**CITY PLANNING COMMISSION**  
1231 "I" STREET, SUITE 200, SACRAMENTO, CA 95814

| <b>FILING DATE:</b> January 22, 1991                               | <b>ENVIR. DET.:</b> Neg. Dec. | <b>REPORT BY:</b> DIH |

- APPLICATION:**
- A. Negative Declaration
  - B. Variance to construct a single family house on a lot with less than 20 feet of street frontage.
  - C. Variance to reduce sideyard setback from 5' to 1' (withdrawn).
  - D. Variance to reduce driveway depth from 20' to 14.5'.
  - E. Variance to reduce rearyard setback area from 15' to 6'.

**LOCATION:** 1039 11th Ave.

**EXHIBIT - A  
SITE PLAN**

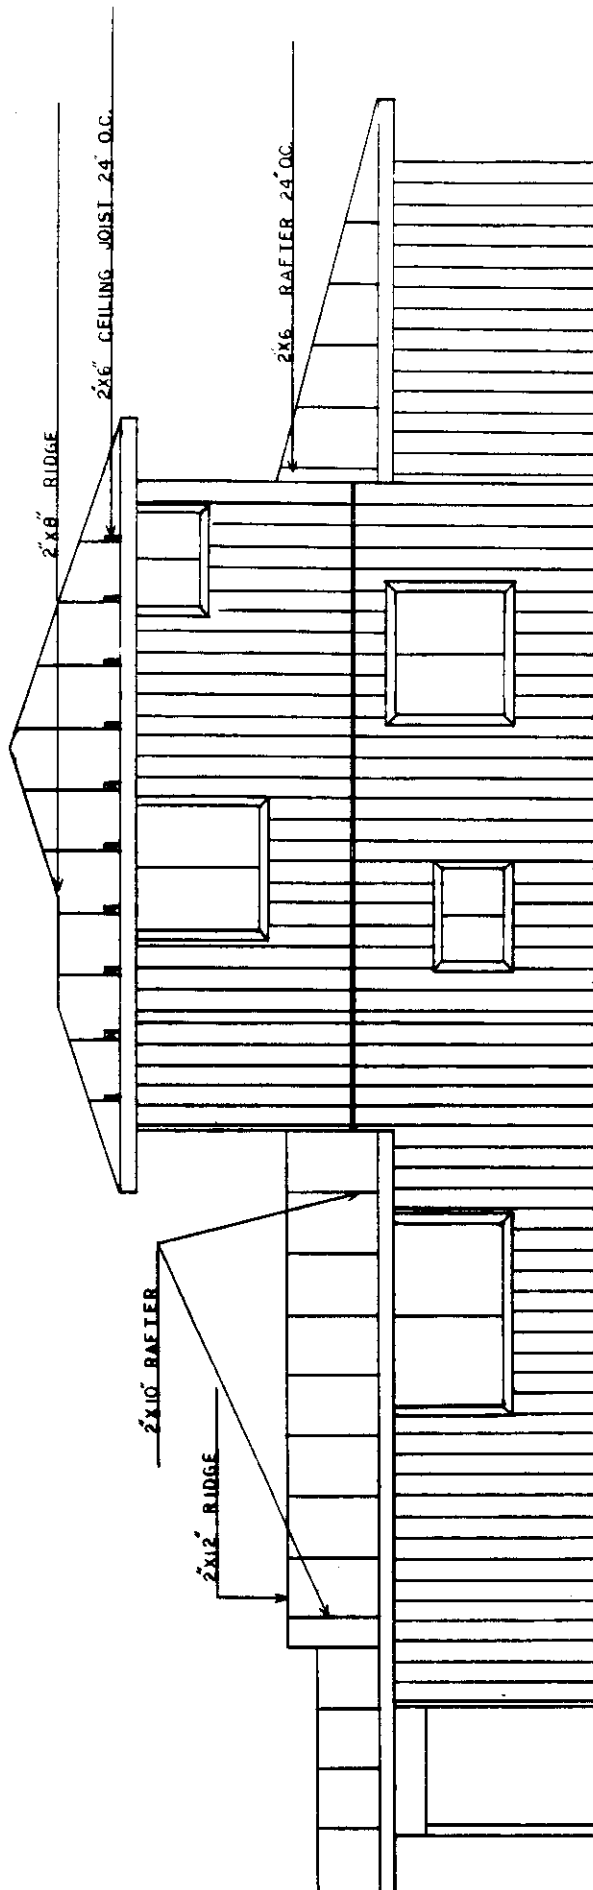
The proposed single family residence would be situated on a triangular lot measuring 48' x 102'1" x 122'3". The lot is at the corner of two unimproved alleys. The proposed driveway to the residence would come off the alley connecting 10th and 11th Avenues. The driveway would measure 14 feet from the shortest point, 18 feet from the longest point, and 16 feet from the midpoint in the driveway. The Zoning Ordinance requires a 20 foot driveway. Staff has no objection to the shorter driveway in this case since it is off of an alley where there are no pedestrian sidewalks nor pedestrians. The residents of the single family units facing Stockton Boulevard use the north-south alley as access to their homes. Several of the garages in the vicinity are situated next to the alley and other garages off the alleys have driveways less than 20 feet deep.

The rearyard area would be reduced to 6 feet from the required 15 feet. The front yard setback is up to 52' from a distance equal to the front of the house to where the lot comes to a point. The shortest front setback distance is 27'. Due to the odd shape of the lot and because the proposed residence would cover 38% of the lot, staff has no objection to the intrusion of the house on the required rearyard setback area. Adequate open space area for occupants of the proposed residence and adequate setbacks from neighboring residential units will be provided. Adequate access to the house will also be provided from the two adjacent alleys.

The applicant has not shown landscaping features or a fence design. The applicant should submit a landscaping plan and a fence design to be approved by the Planning Director.

The project was reviewed by the Engineering Development and Traffic Engineering Divisions. There was concern expressed over the driveway depth. The Traffic Engineer, as general policy, is not in favor of providing

driveway depth of less than 20 feet. As previously mentioned, staff does not have a concern over the proposed driveway depth in this instance.

- 2. The applicant shall submit landscaping, fence, and revised building plans subject Planning and Design Review staff approval before issuance of a building permit. The plans shall contain the following features:

**EXHIBIT - B**  
**ELEVATIONS**

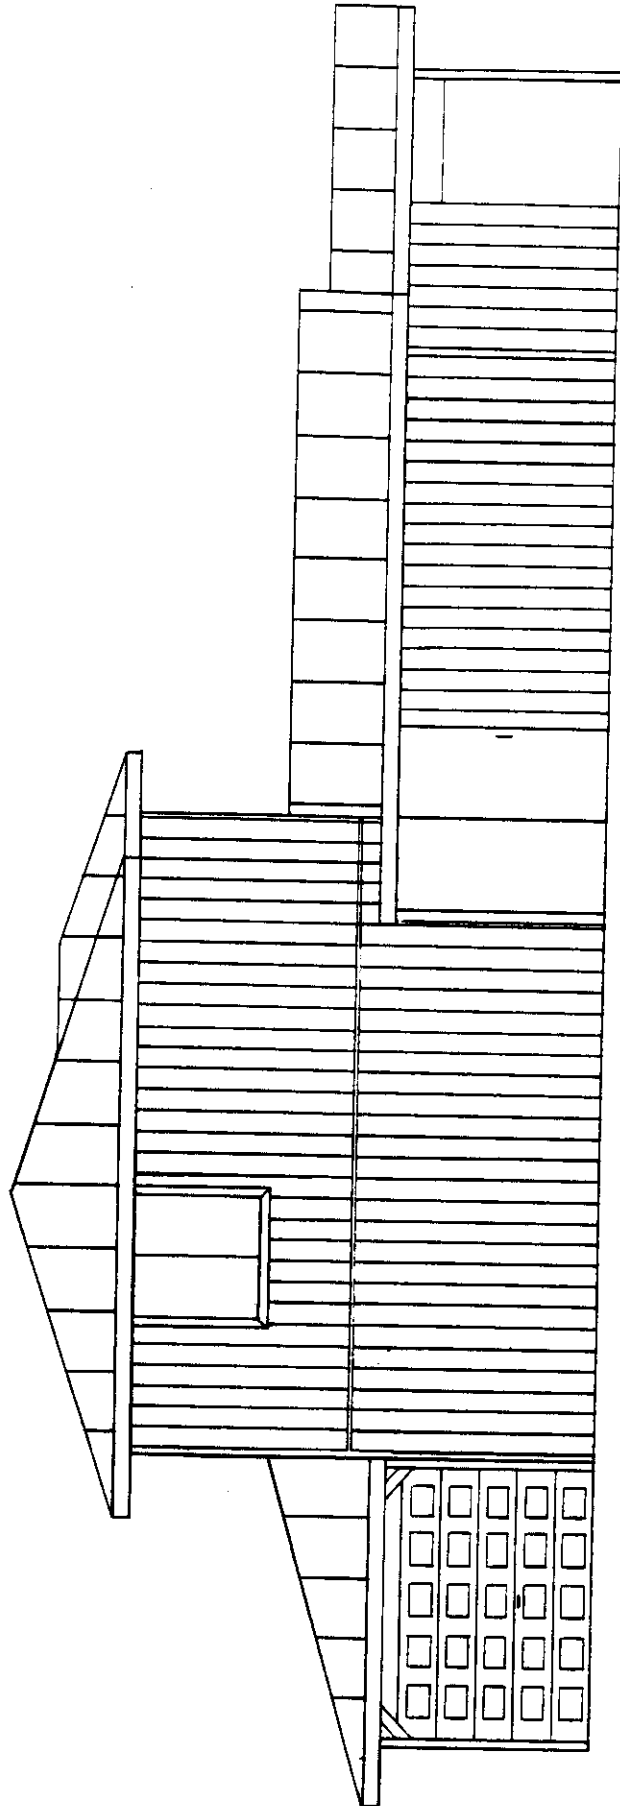
The building materials consists of T1-11 exterior siding and laminated composition shingles on the roof. The exterior building color is proposed to be a dark gray. The proposed building would be a split level. The first floor would contain approximately 721 sq. ft. and the upper floor would contain approximately 394 sq. ft. The upper story would be situated approximately midway over the first story portion. Staff has concerns regarding the design of the structure. The design improvements should contain, but not be limited to, the following features: The siding of the house should have accent trimming where the T1-11 panels come together and around the doors and windows. Stucco with wood trim would be a better choice. The roof should be redesigned with slanting ends to match the angle of the higher roof. There should be corbels (ornamental roof supports) at various locations. The windows and sliding glass door onto the patio should have gridded panes. The doors and garage door should have panels. The roof should be covered with laminated composition shingles.

- a. The siding shall be of stucco or the T1-11 shall have accent trimming where the T1-11 panels come together and around the doors and windows.
  - b. The roof shall be designed with slanted ends to match the angle of the higher roof.

- c. Corbels shall be placed at various locations according to staff recommendation.
  - d. The windows and sliding glass door onto the patio shall have gridded panes.

- e. The doors and garage door shall have panels.

- f. The roof shall be covered with laminated composition shingles.
